AMD-K6[®]

Processor Revision Guide

Model 7

Publication # 21846 Rev: H Amendment/ 0 Issue Date: June 1999
--

Figure 1. AMD-K6[®] Processor Assertion of HLDA Due to Simultaneous $\overline{\text{BOFF}}$ /HOLD Assertion

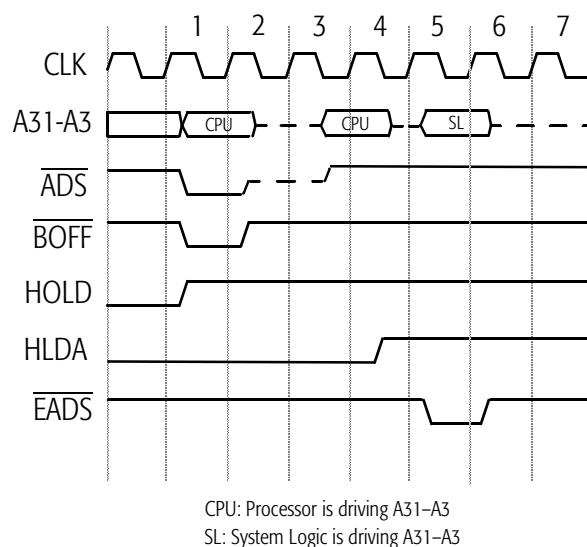
2.2.2 HLDA Assertion Delayed by One Clock

Non-conformance. If $\overline{\text{BOFF}}$ and HOLD are sampled asserted on the same clock edge that negates $\overline{\text{ADS}}$, the processor asserts HLDA two clock edges after HOLD is sampled asserted.

Potential Effect on System. There are three potential effects of this erratum to consider:

- If the system logic asserts $\overline{\text{BOFF}}$ for a duration of one clock, anticipates the assertion of HLDA in clock 3 (see Figure 1)—which is the normal specified operation—and drives the address bus and $\overline{\text{EADS}}$ for an inquire cycle in clock 3, then the processor will not sample $\overline{\text{EADS}}$ asserted. In addition, address bus contention will occur in clock 3.

- If the system logic asserts $\overline{\text{BOFF}}$ for a duration of two clocks, anticipates the assertion of HLDA in clock 3, and drives the address bus and $\overline{\text{EADS}}$ for an inquire cycle in clock 3, then the processor will not sample $\overline{\text{EADS}}$ asserted. (No address bus contention occurs in this case.)

- If the system logic asserts $\overline{\text{BOFF}}$ for a duration of one clock, anticipates the assertion of HLDA in clock 3, and drives the address bus and $\overline{\text{EADS}}$ for an inquire cycle in clock 4, then address bus contention may occur in clock 4. (The processor will sample $\overline{\text{EADS}}$ asserted in this case.)

If the processor does not sample $\overline{\text{EADS}}$ asserted during an inquire cycle, cache/memory incoherency will occur. Address bus contention can affect the reliability of the processor and the system logic.

Suggested Workaround. The system logic must sample the assertion of HLDA before asserting $\overline{\text{EADS}}$ and driving the address bus for an inquire cycle—as shown in clock 5 of Figure 1.

Resolution Status. AMD has determined that all Socket7 and Super7[™] chipsets operate as described in the aforementioned suggested workaround. Therefore, AMD has decided to defer the resolution of this erratum until deemed necessary.
